Volume: XIX
 Number: TC13-010
 Date: 04/03/2013
 Action
 Retain
 Information

To: All Toyota Region/Private Distributor General Managers/Vice Presidents
 From: Bob Waltz, *[Signature]*
 Vice President, Product Quality and Service Support
 Subject: **Owner's Manual Update**
 2008 through 2012 Model Year Highlander and Highlander Hybrid Vehicles

PRODUCT UPDATE
Owner's Manual Update

Sample Owner's Manual Page(s)

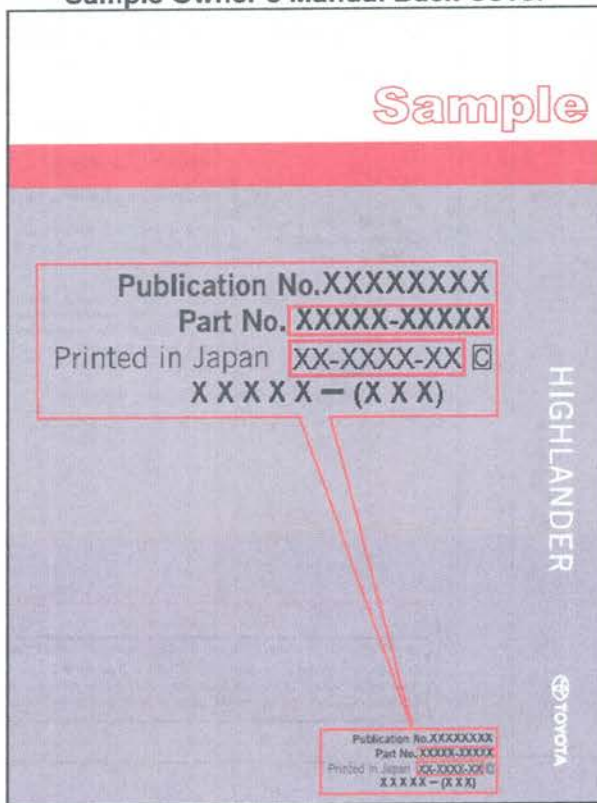
When towing trailer
Add 6 psi (40kPa, 0.4kgf/cm² or bar) to the rear tires. Never exceed the maximum cold tire inflation pressure indicated on the tire sidewall.

Sample Owner's Manual Page(s)

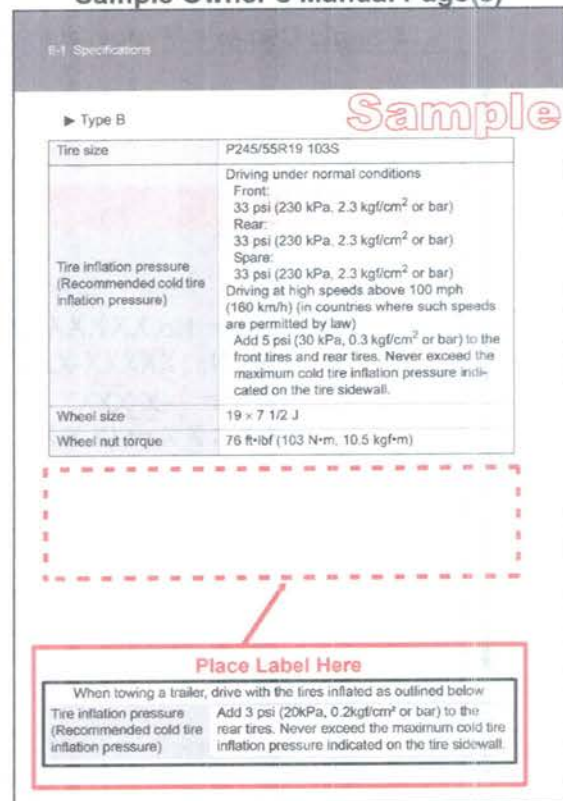
Model	MY	Part Number	Printed in Japan	Pages Requiring Label	
When towing a trailer, drive with the tires inflated as outlined below. Tire inflation pressure (Recommended cold tire inflation pressure) Add 3 psi (20kPa, 0.2kgf/cm ² or bar) to the rear tires. Never exceed the maximum cold tire inflation pressure indicated on the tire sidewall.	Highlander Hybrid	2008	ALL	--	p. 540	p. 542
		2009	ALL	--	p. 548	p. 550
		2010	ALL	--	p. 550	p. 552
		2011	--	01-1008-00	p. 564	p. 566
			--	02-1009-01	p. 566*	
			--	03-1105-02	p. 566*	
		2012		01999-48D03	p. 582	
	01999-48A10**		-

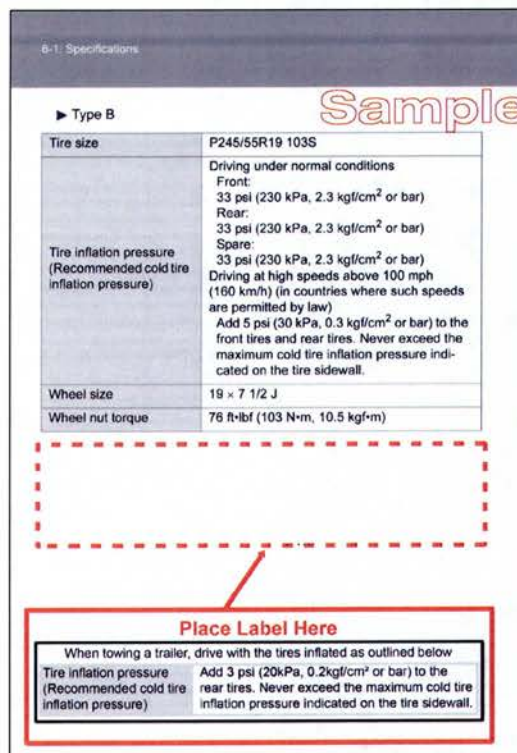
2. Place the enclosed update label(s), as shown in the figure below, on the page(s) (as indicated in step 1) of your Owner's Manual.

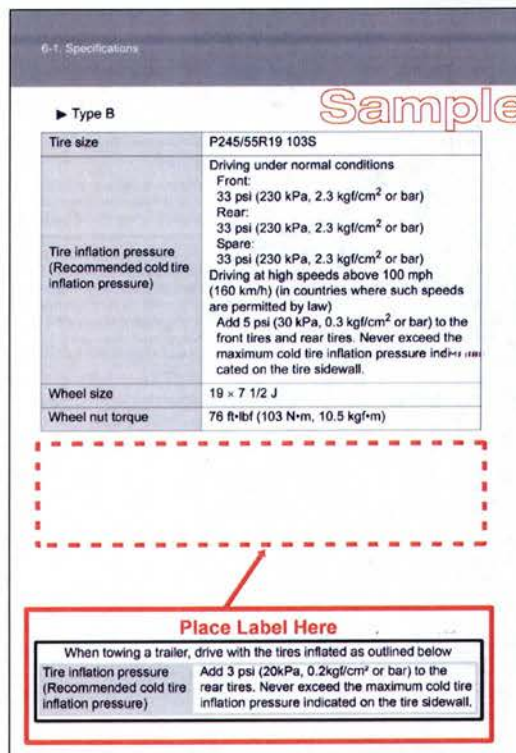
2. If the part number is 01999-48D03 place the update label, as shown in the figure below, on page 582 of your Owner's Manual.

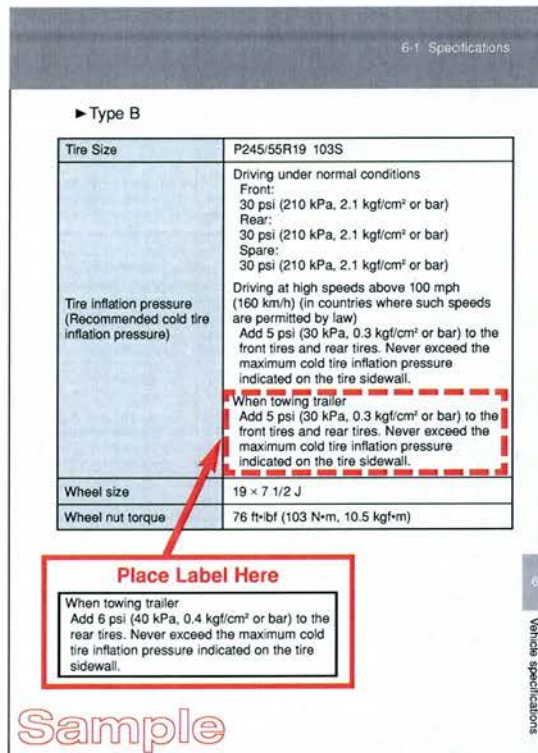
2. Place the enclosed update labels, as shown in the figure below, on the appropriate pages (as indicated in step 1) of your Owner's Manual.

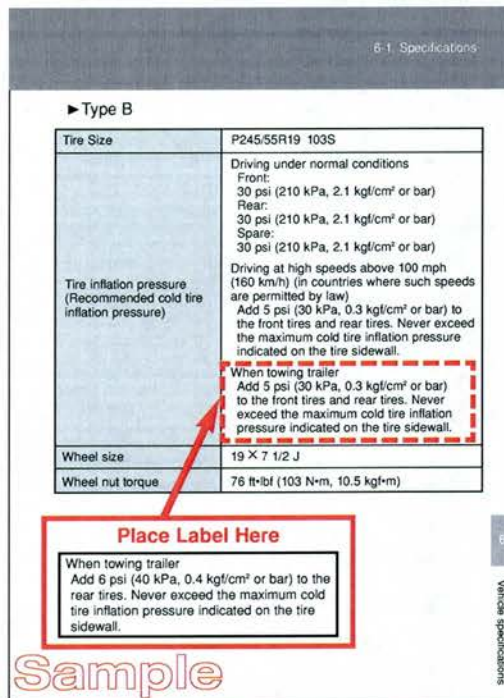
2. Place the enclosed update label(s), as shown in the figure below, on the appropriate page(s) (as indicated in step 1) of your Owner's Manual.

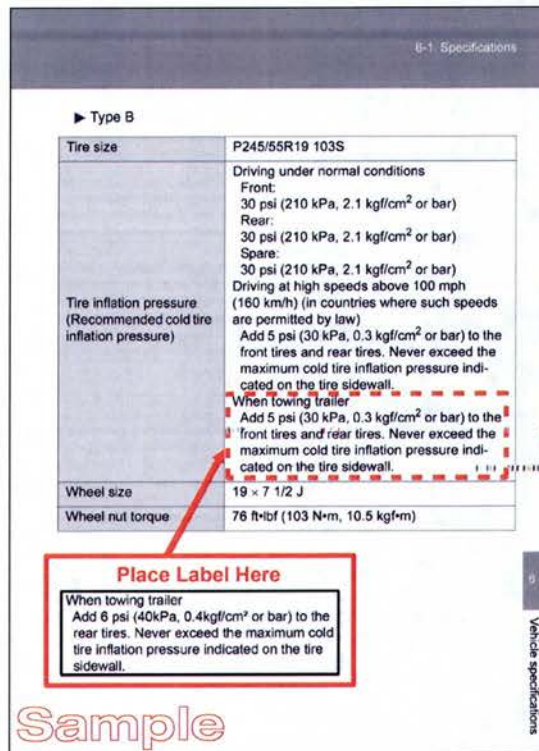
2. Place the enclosed update label, as shown in the figure below, on the appropriate page (as indicated in step 1) of your Owner's Manual.

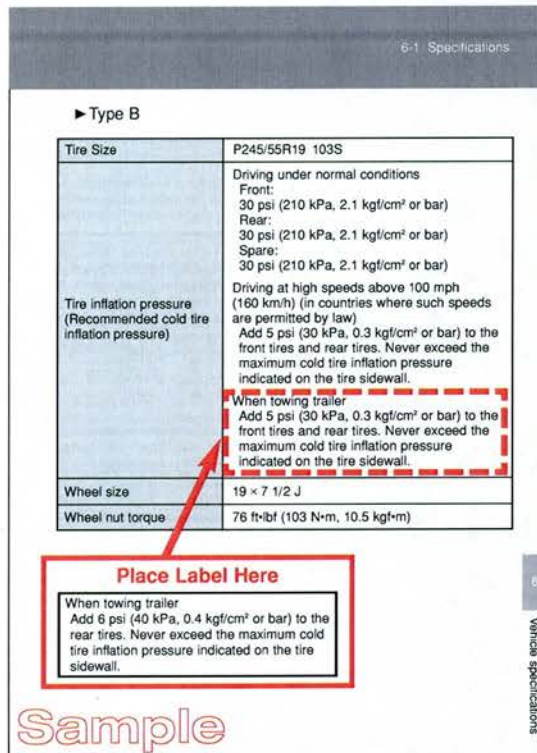
2. Place the enclosed update labels, as shown below, on the appropriate pages (as indicated in step 1) of your Owner's Manual.

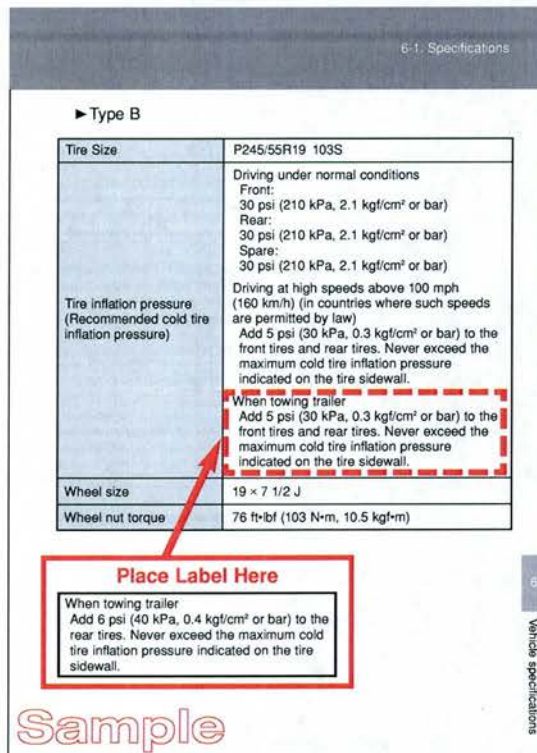
2. Place the enclosed update labels, as shown in the figure below, on the appropriate pages (as indicated in step 1) of your Owner's Manual.
